September 15, 2009

Subject: UniStar Nuclear Energy, NRC Docket No. 52-016  
Response to Request for Additional Information for the  
Calvert Cliffs Nuclear Power Plant, Unit 3  
RAI No. 58, Seismic Design Parameters, Questions 03.07.01-1 and 03.07.01-10  
RAI No. 65, Seismic System Analysis, Questions 03.07.02-18 and 03.07.02-24  
RAI No. 112, Seismic Design Parameters; Question 03.07.01-11

**Response to NRC Request for Additional Information,  
RAI No. 58, Seismic Design Parameters, Questions 03.07.01-1 and 03.07.01-10,  
RAI No. 65, Seismic System Analysis, Questions 03.07.02-18 and 03.07.02-24, and  
RAI No. 112, Seismic Design Parameters; Question 03.07.01-11  
Calvert Cliffs Nuclear Power Plant, Unit 3**

**Figure 3.7-42-{CCNPP Unit 3 NAB Basemat X-Direction Spectra (5% Damping)}**

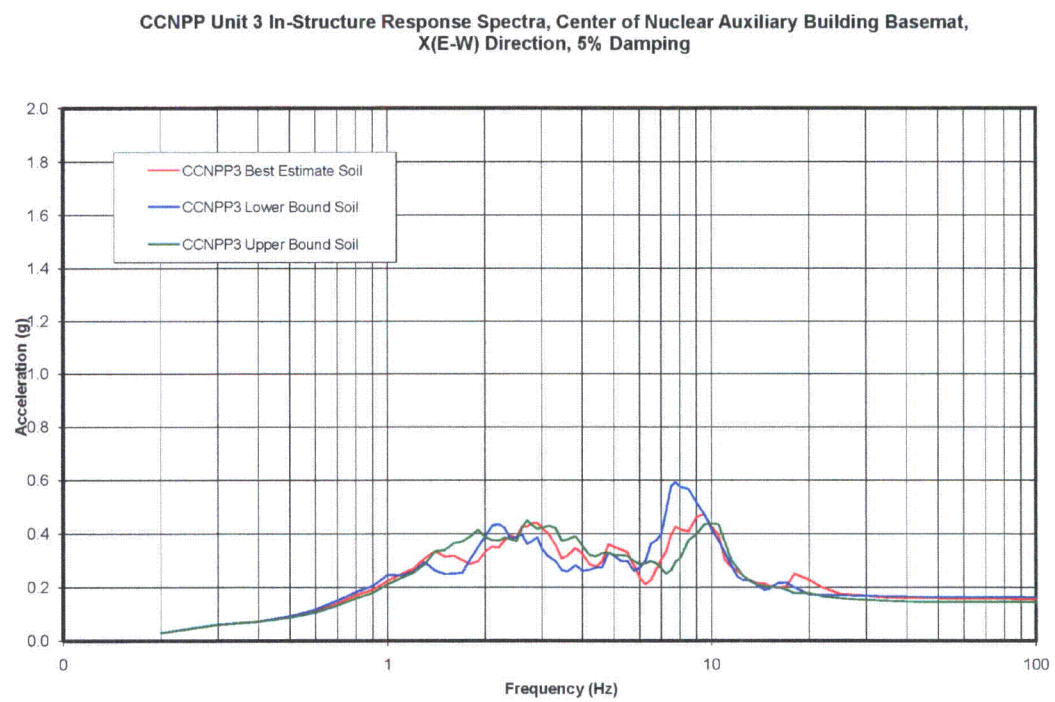
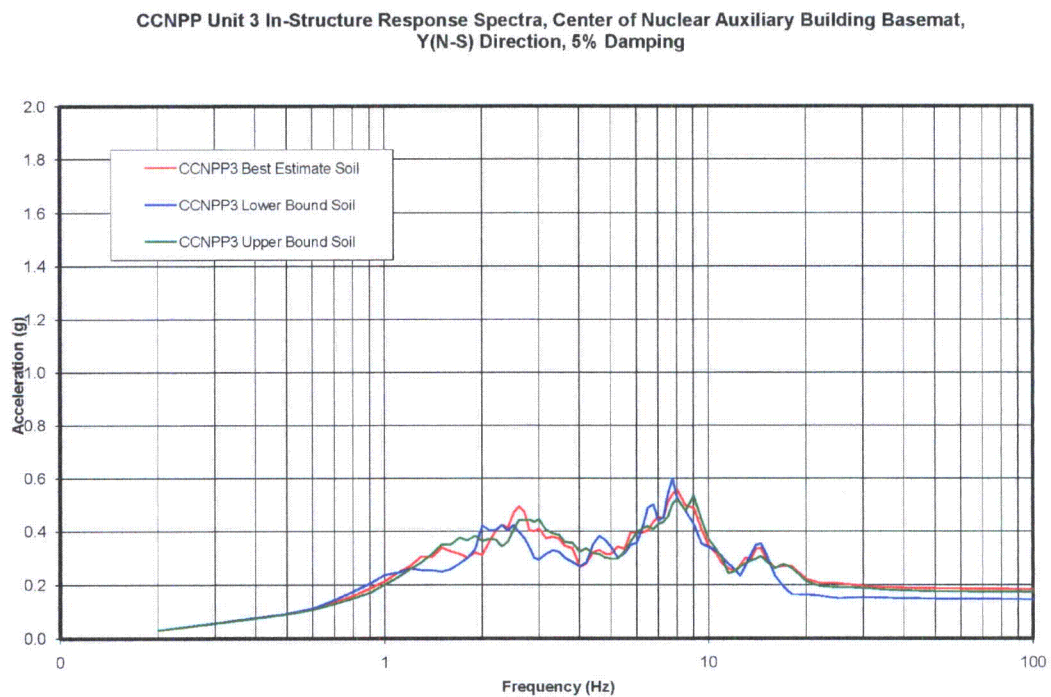
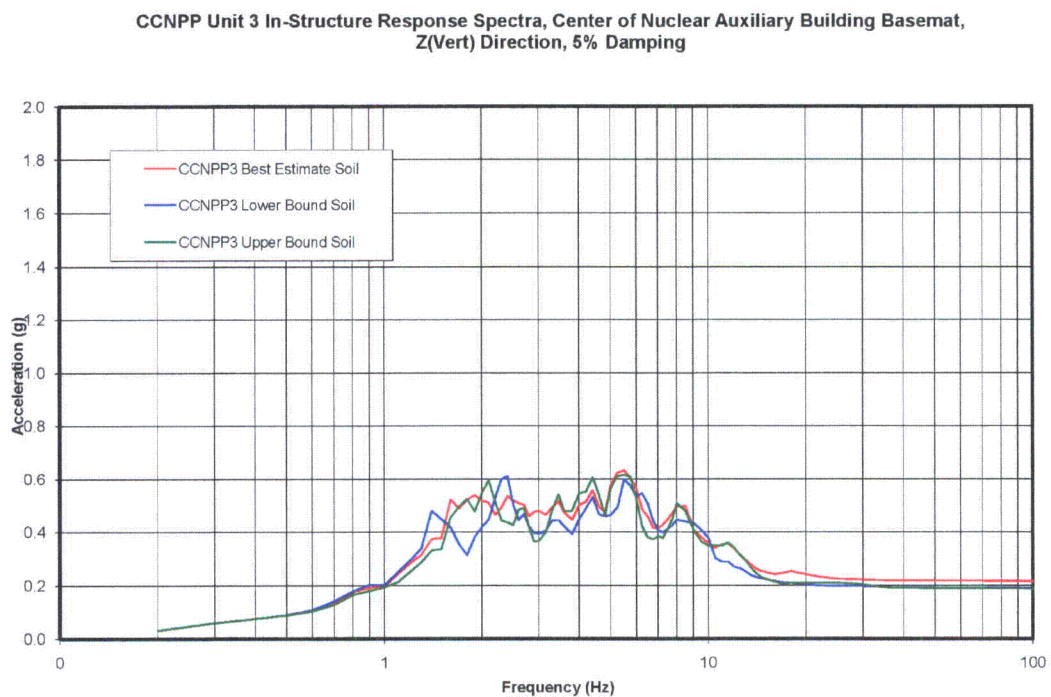
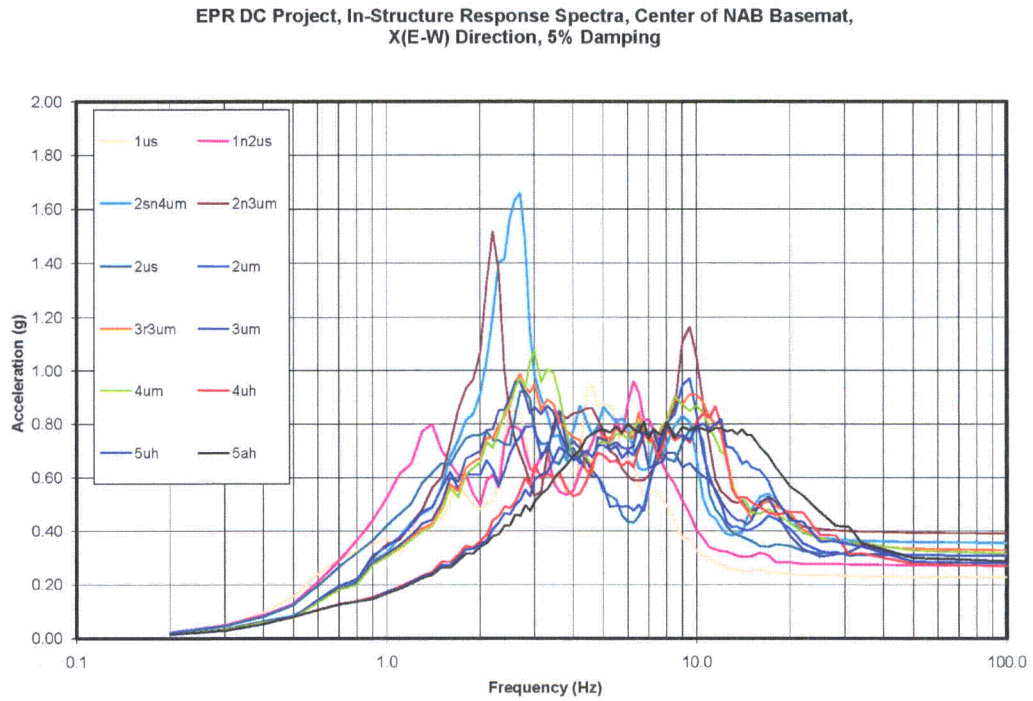
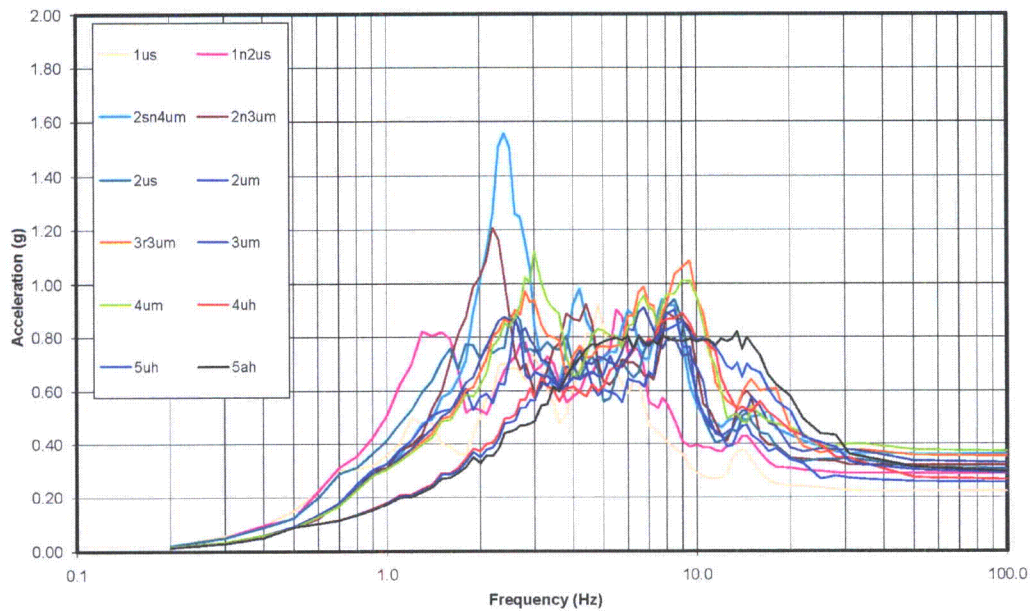
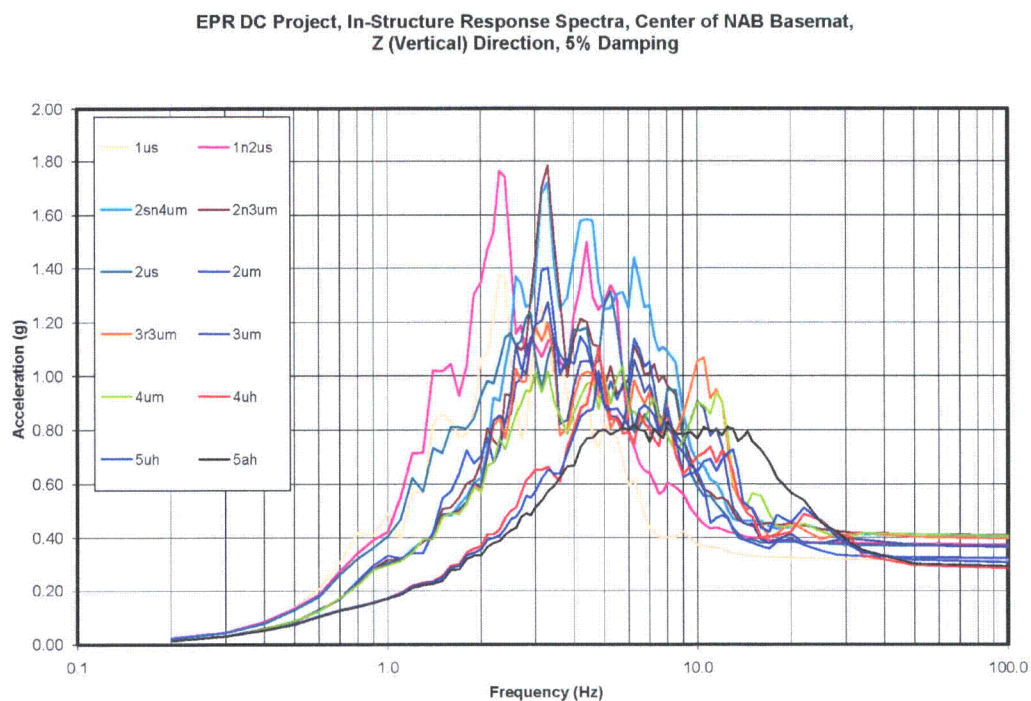
- The Fire Protection Tanks and Fire Protection Building are classified as Seismic Category II-SSE in the CCNPP Unit 3 FSAR. This is an exception to the U.S. EPR FSAR which classifies them as conventional seismic. Please revise this section of the CCNPP FSAR to identify and clarify this difference.
- A seismic analysis was performed for the NAB in the U.S. EPR FSAR. Since this structure could potentially interact with Seismic Category I structures, the CCNPP FSAR needs to reconcile the U.S. EPR analysis with the site-specific soil properties and foundation input response spectra (FIRS) for the NAB. Also demonstrate in the FSAR that the displacement of this structure relative to the nuclear island common basemat structure is enveloped by the results of the U.S. EPR analysis.

Based on the site-specific SSI analyses performed for the Nuclear Island (NI) common basemat structures, response spectra at the basemat of the Nuclear Auxiliary Building (NAB) were generated for lower bound, best estimate, and upper bound soil cases in the X, Y, and Z directions as shown in the attached RAI response figures (Figures 3.7-42, 3.7-43 and 3.7-44). Similarly, the response spectra generated from the supporting analyses performed for the U.S. EPR design are shown in Figures 3.7-45, 3.7-46 and 3.7-47. These figures will be added to the CCNPP Unit 3 FSAR. Comparison between the two sets of figures indicates that the site-specific response spectra at the basemat of the NAB is significantly lower than for U.S. EPR design. It can therefore be concluded that the displacement of the NAB relative to the NI common basemat structure is enveloped by the results of the U.S. EPR analysis.

- FSAR Figure 3.7-42 through Figure 3.7-47 will be added as described in the response.
- Modifications to FSAR Section 3.7.2 including a discussion of the new figures are provided in the response to RAI 65 Question 03.07.02-24 (this enclosure).

**Figure 3.7-48—{CCNPP Unit 3 Radioactive Waste Processing Building  
Basemat X-Direction Spectra (5% Damping)}**

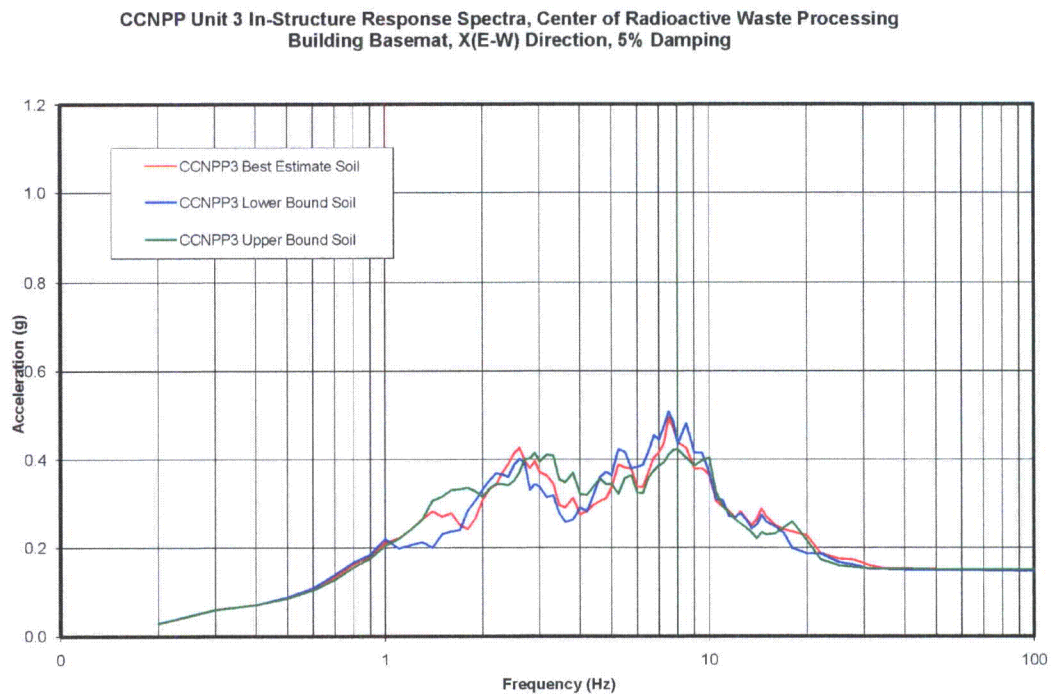
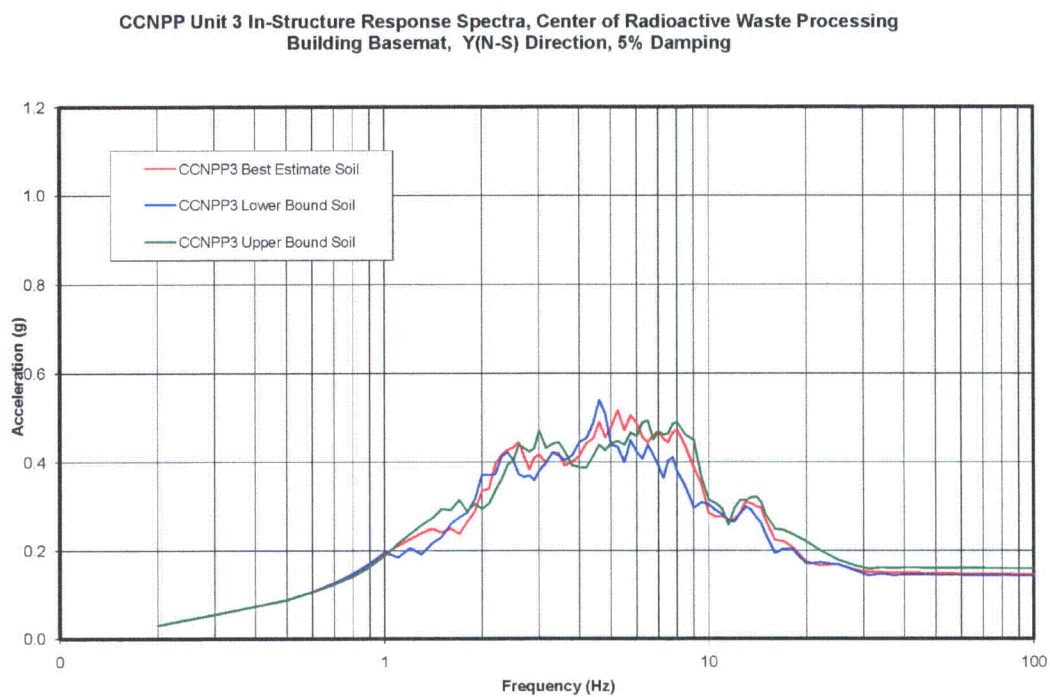
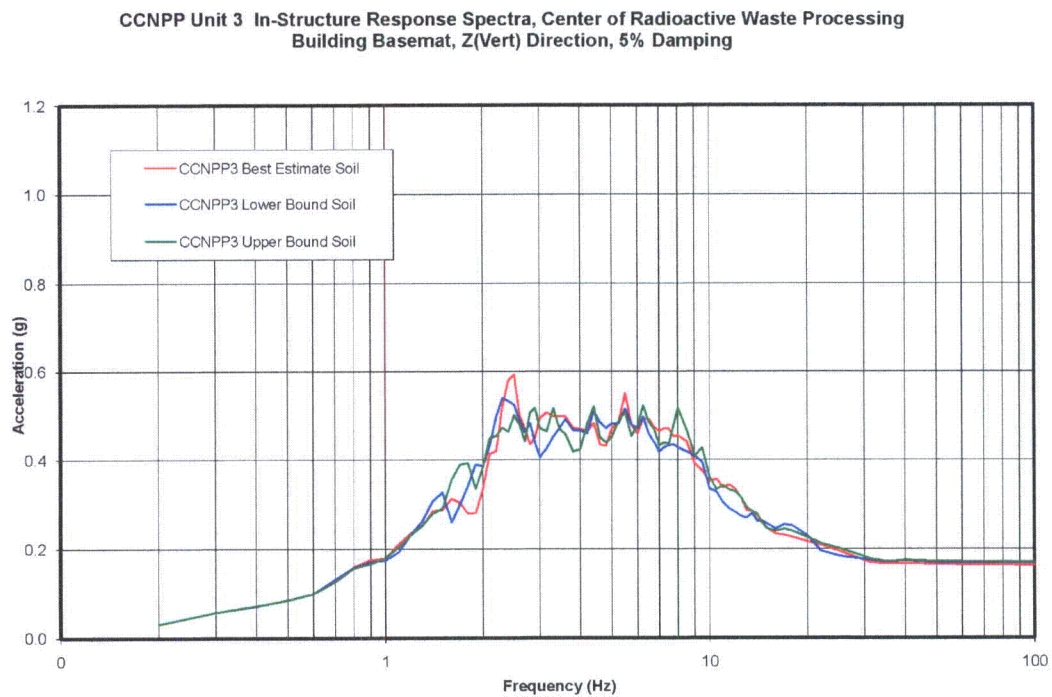
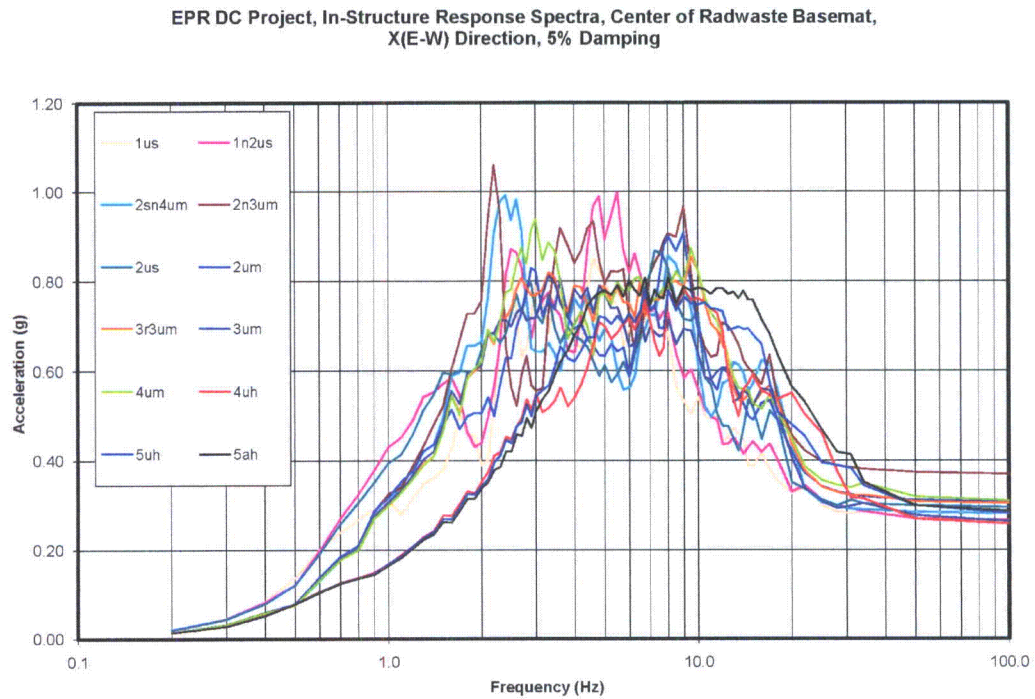
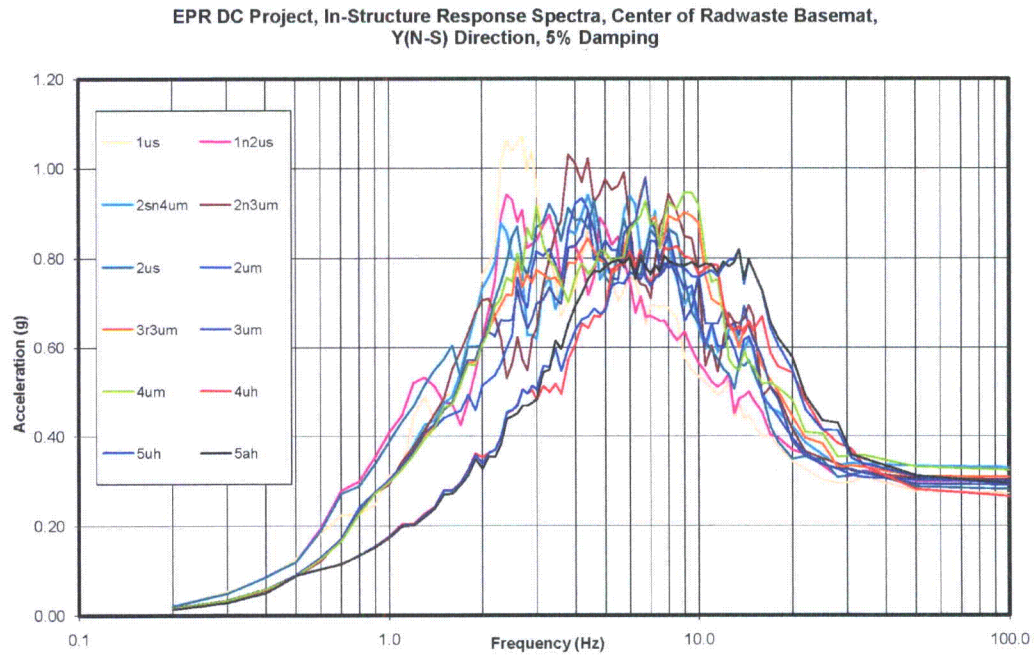
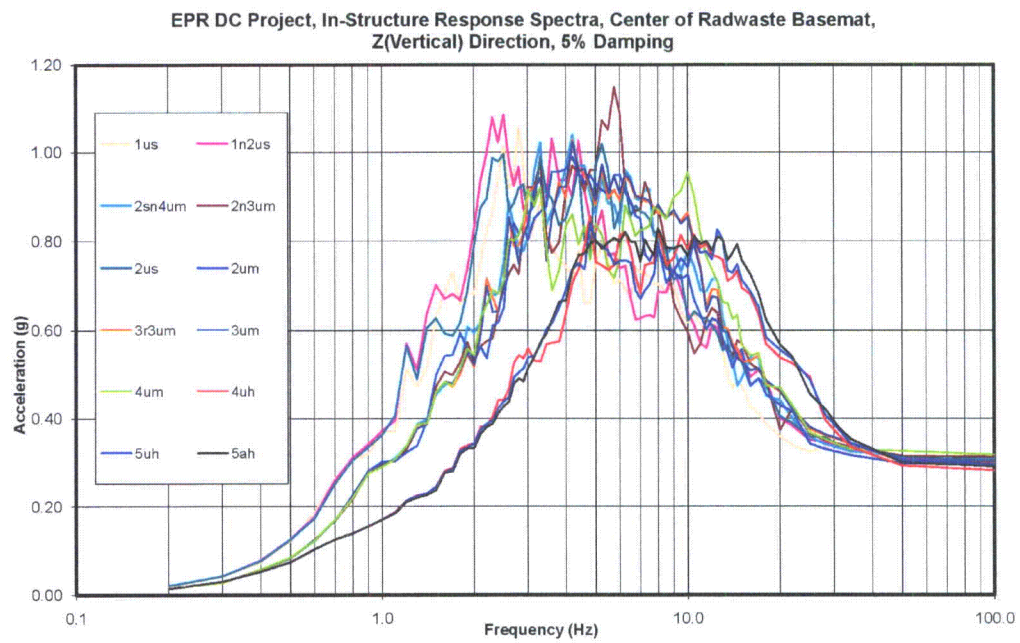
U.S. EPR COL Information Item 3.7-1 states that a COL applicant that references the U.S. EPR design certification will confirm that the site-specific seismic response is within the parameters of Section 3.7 of the U.S. EPR standard design. In its response, the applicant has not addressed, the nuclear island common basemat structures, seismic Category II structures, the Nuclear Auxiliary Building and the Radioactive Waste Processing Building, and should do so to fully respond to this information item. The applicant is requested to provide a summary for each structure, either directly or by reference, which describes how the COL item is met.

Responses at the center of basemats of these structures were computed from the site-specific SSI analysis of the NI mentioned above. The response to RAI 65, Question 03.07.02-18 (this enclosure), shows that site-specific response for the NAB is enveloped by U.S. EPR standard design response. The same conclusion may be drawn by comparing the site-specific responses (shown in attached Figures 3.7-48 through 3.7-50) at the basemat for RWPB to the corresponding U.S. EPR standard design responses (shown in attached Figures 3.7-51 through 3.7-53). Therefore, it is confirmed that the site-specific seismic responses for the NAB and RWPB are within the parameters of Section 3.7 of the U.S. EPR standard design. FSAR Section 3.7.2 will be revised to address the NAB and the RWPB. Also, new figures will be added to address the RWPB.

FSAR Section 3.7.2 will be revised as follows and FSAR Figures 3.7-48 through 3.7-53 will be added in a future COLA revision. New Figures 3.7-42 through 3.7-47 were provided in the response to RAI 65 Question 03.07.02-18 (this enclosure).

The site-specific seismic responses for the Nuclear Auxiliary Building (NAB) and Radioactive Waste Processing Building (RWPB) are within the parameters of Section 3.7 of the U.S. EPR standard design. The seismic responses at the center of basemats of the NAB and RWPB structures were computed from the site-specific SSI analysis for the Nuclear Island common basemat structures described in Section 3.7.1.1.1. The site-specific response for the NAB is enveloped by U.S. EPR standard design response as shown by comparing the site-specific responses (Figures 3.7-42 through 3.7-44) at the basemat for NAB to the corresponding U.S. EPR standard design responses (Figures 3.7-45 through 3.7-47). The site-specific response for the RWPB is enveloped by U.S. EPR standard design response as shown by comparing the site-specific responses (Figures 3.7-48 through 3.7-50) at the basemat for RWPB to the corresponding U.S. EPR standard design responses (Figures 3.7-51 through 3.7-53).
